Acknowledgement of Plans Submittal ONLY!

BUILDER: PLANSINC.com Stock Pl...

PLAN NAME: TR40-1612

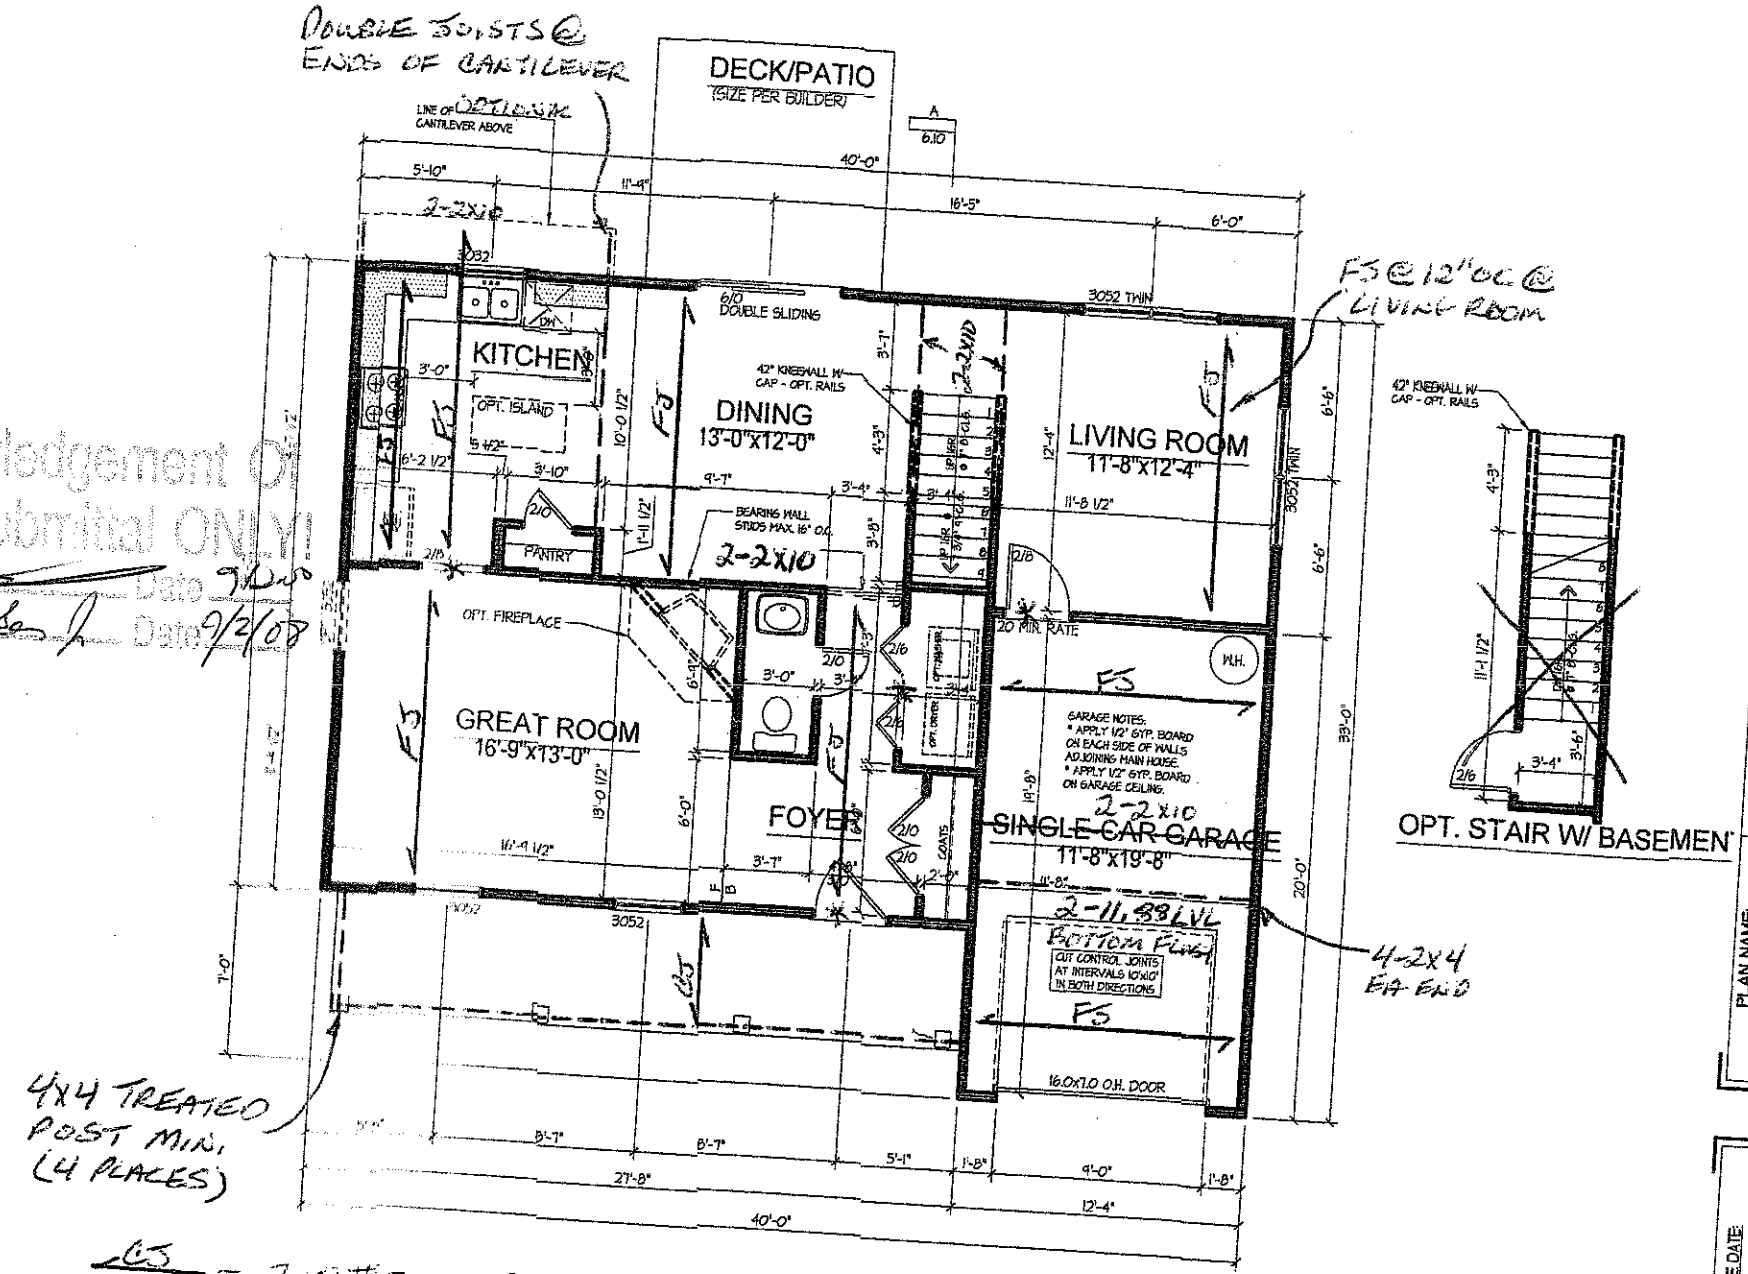
FJ = 2x8 #2 SYP @16"oc

FJ = 2x10 #2 SYP @16"oc

All first floor window headers are 2-2x10 #2 SYP with 2-2x4 jacks and 1-2x4 king. Only 1 2x4 king

Garage Door Header is 2-9.25" LVL w/ 2-2x4 Jacks and 3-2x4 Kings at ea end.

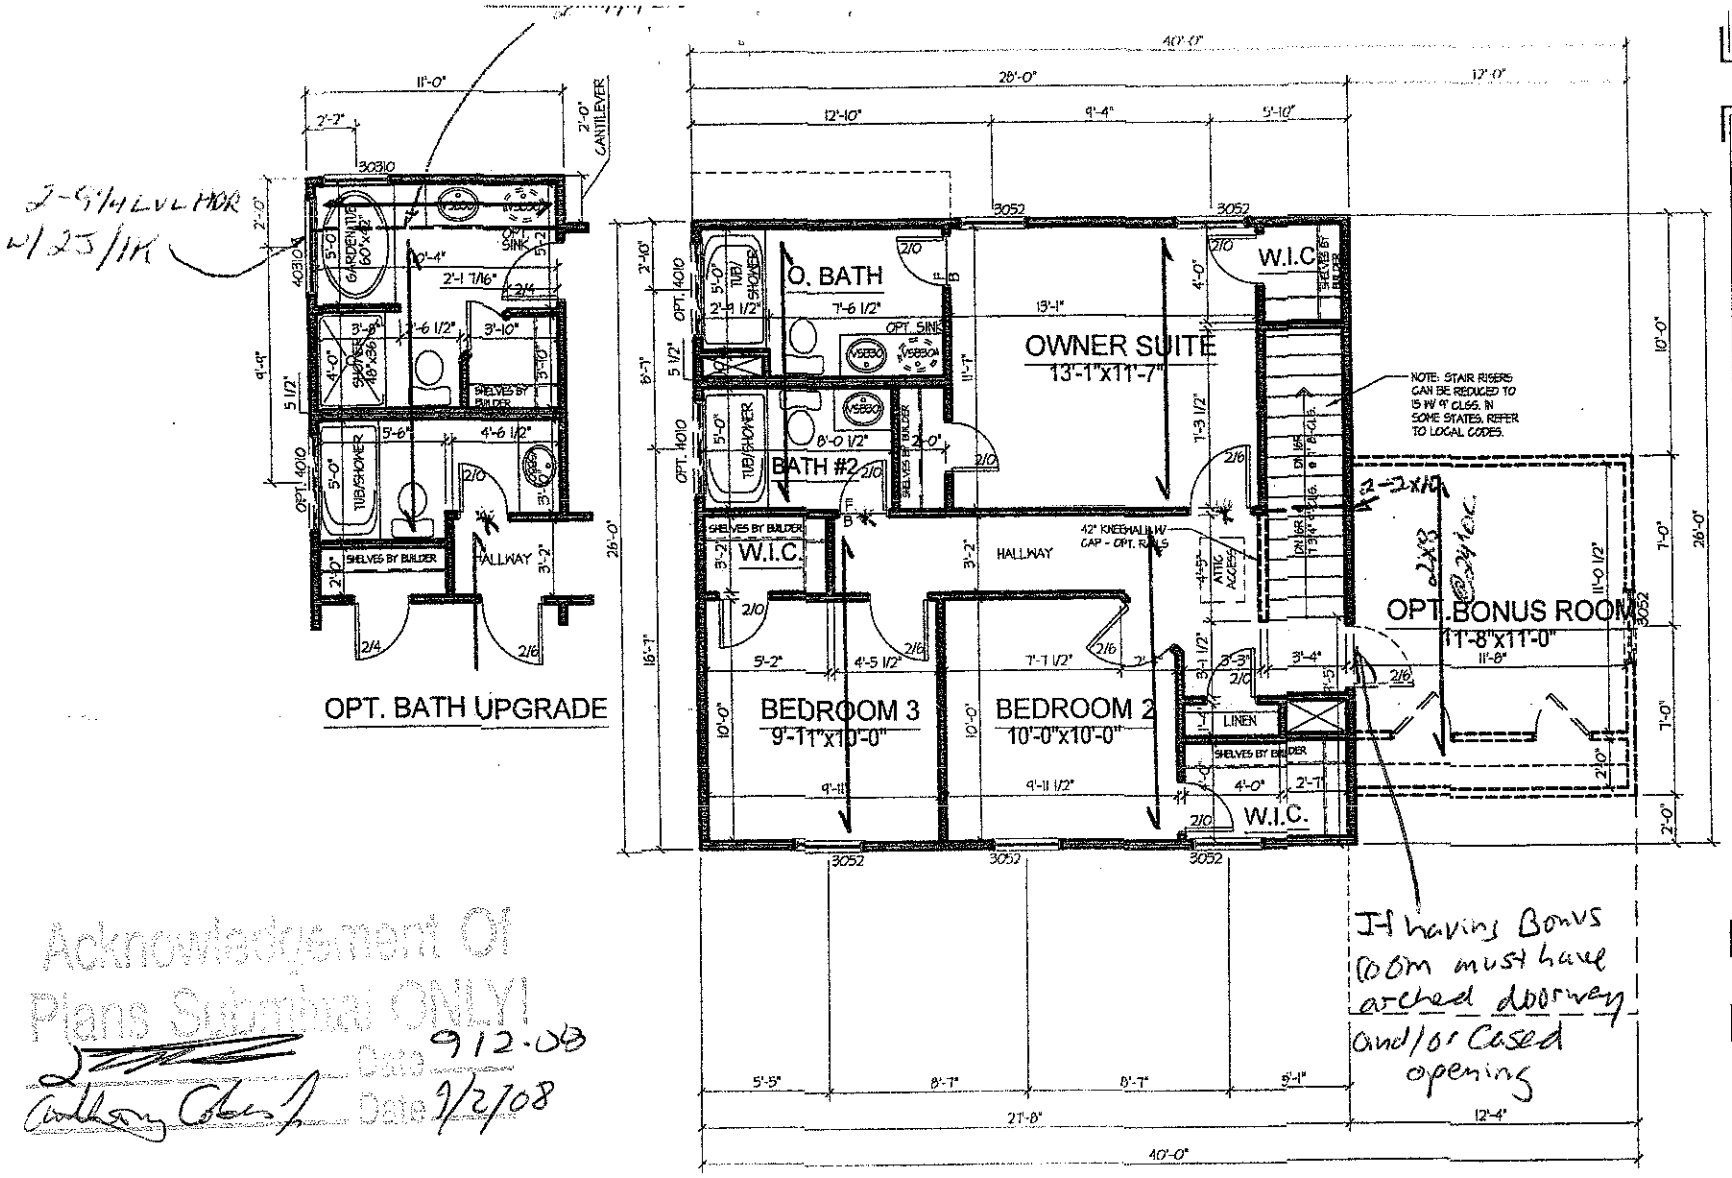
All second floor window headers are 2-2x10 #2 SYP with 2-2x4 jacks and 1-2x4 king. Only 1-2x4 jack required for windows less than 6' wide.

*** Interior load bearing wall door headers are 2-2x10 #2 SYP with 1-2x4 jack and 1-2x4 king.**
